SERVICE BULLETIN

No. 1787

TITLE: R-1340 CYLINDER HEAD - FLUORESCENT PENETRANT INSPECTION AND VISUAL INSPECTION OF

ENGINES AND MODELS AFFECTED: R-1340, Wasp Engines, All Models.

CYLINDER HEAD SHOWING FINS NO. 7 - NO. 9
FIGURE 1

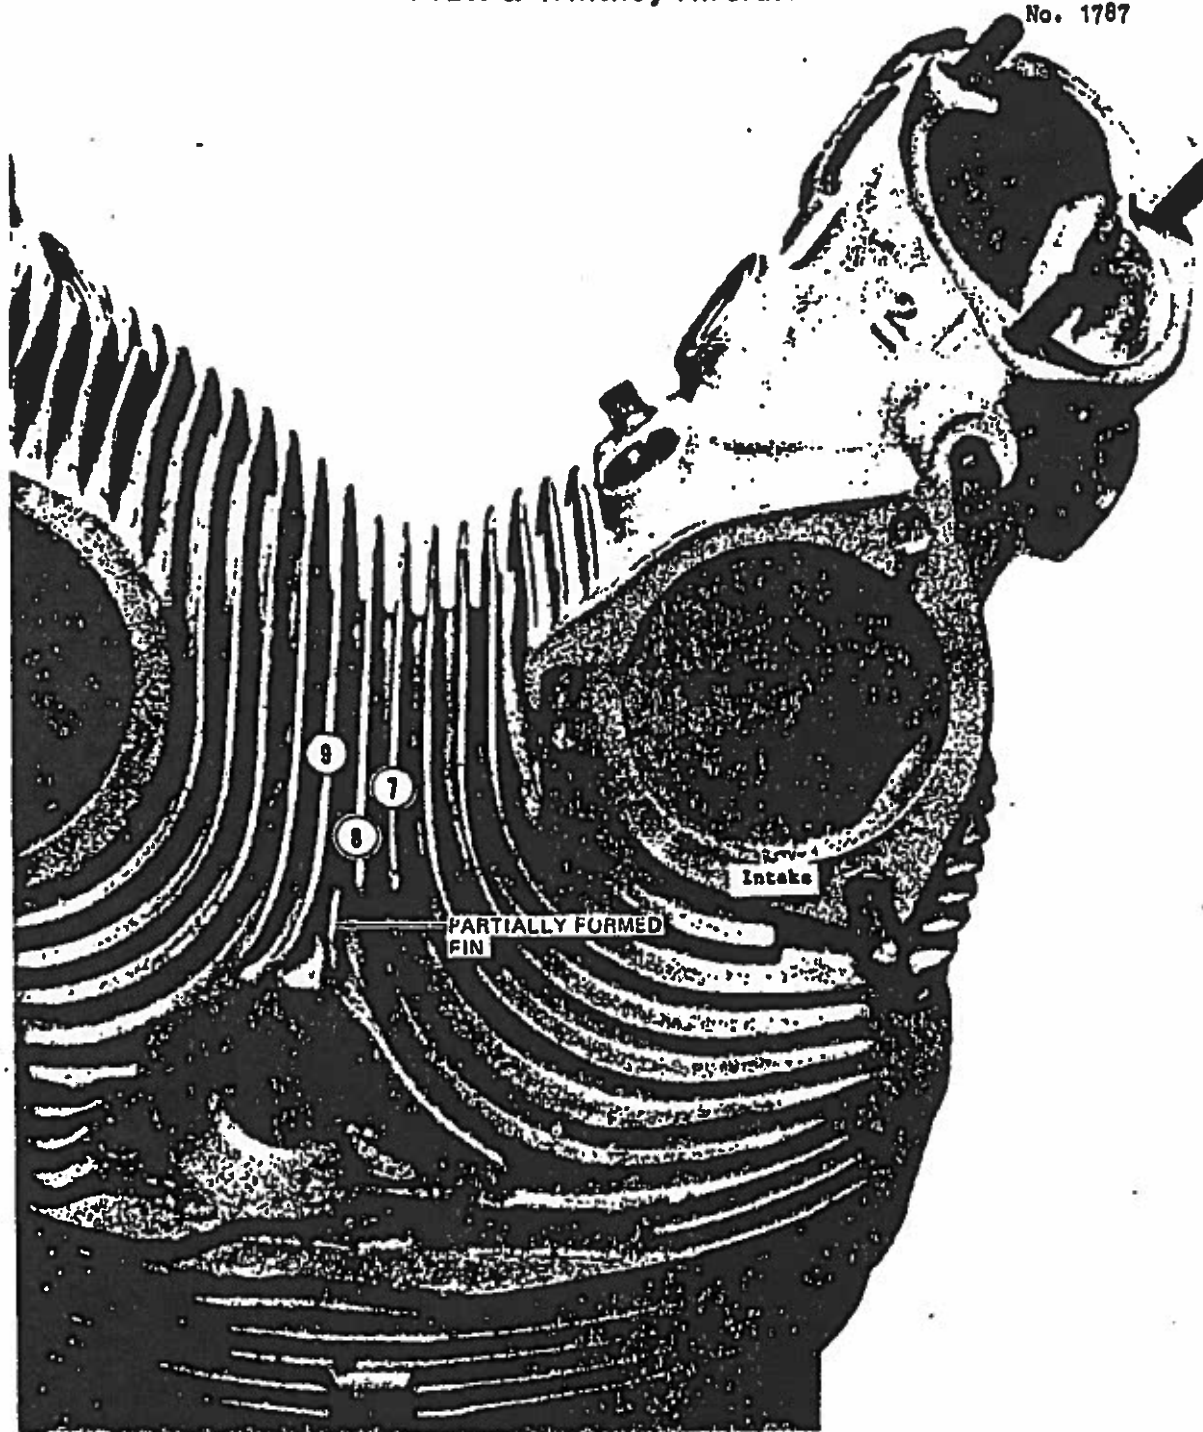
- B. Fluorescent penetrant inspect cylinder head Fins Nos. 7 - 8, and 8 - 9, along the outer surface of the fin roots over the cylinder head dome between the front and rear spark plug holes and including the partially formed cooling fin by the rear spark plug hole. See Figure 1. Carefully mark fins with pencil marks to enclose areas where defects are indicated. See Reference (1). The following inspection standards will apply;

A. For installed engines, visually inspect top of cylinder heads between Fins No. 7 and No. 9 (see Figure 1) as follows:

- (3) Using sufficient light, visually inspect between the central cooling fins (Fins No. 7 - No. 9) over the top of the cylinder head between front and rear spark plug openings. If crack over one inch in length is visible, or if black combustion leakage is found, replace cylinder assembly. Return rejected cylinder assembly to overhaul for inspection and salvage of usable parts.

- D. Rework Procedure;
 - (1) Using milling machine or a portable power tool and a 1/8 - 1/4 inch diameter end mill, machine over the top of cylinder head to remove the section of #8 or #9 fin containing a root crack or the section of #8 or #9 fin closest to root crack, between inspection marks. Machine fin down to root removing fin pedestal smoothly. Round edges of fin at cut out.

- (2) Using a milling machine or portable power tool and a 1/8 inch diameter end mill with a full radius end, rout out crack in root to 0.150 inch maximum depth. Scan defect area to assure complete crack removal. Remove all cylinder heads, with deeper cracks, from service. Blend ends and sides of crack cavity smoothly.
